UNITED STATES PATENT AND TRADEMARK OFFICE

APPLICATION NO.	FILING DATE	FIRST NAMED INVENTOR	ATTORNEY DOCKET NO.	CONFIRMATION NO.
10/694,749	10/29/2003	William DeToro	3934	5373

Office Action Summary

DETAILED ACTION

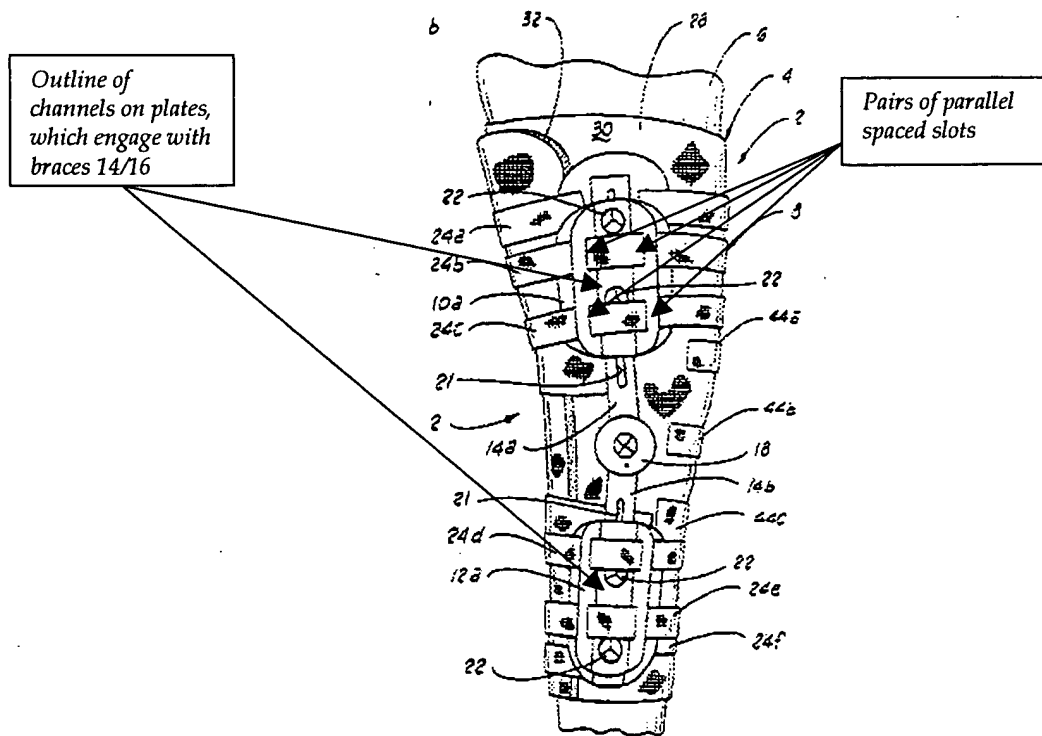
Regarding claim 5, the means for adjustably securing said knee immobilization brace to the wearer's leg comprises a plurality of straps (24a-c) adjustably extending from multiple strap mounting slots (see column 3, lines 49-54 and Figure below) in said respective upper and lower leg engagement portions, and strap to strap interengagement means (26) thereon. Regarding

claim 10, the strap mounting slots further comprise oppositely disposed pairs of parallel spaced slots in longitudinally spaced relation (see Figure below) on said respective upper and lower leg engagement plates.

Regarding claim 6, the upper and lower leg engagement plates are transversely contoured to registerably engage the wearer's leg (see plates engaged against leg in Figures 1 and 2), and a mounting channel (see outlines of channel in Figure 2 below) is defined in each of said upper and lower leg engagement plates, wherein the channel of the leg engagement plates cooperates with the vertical braces (14/16) to allow vertical movement of the leg engagement plates along the braces.
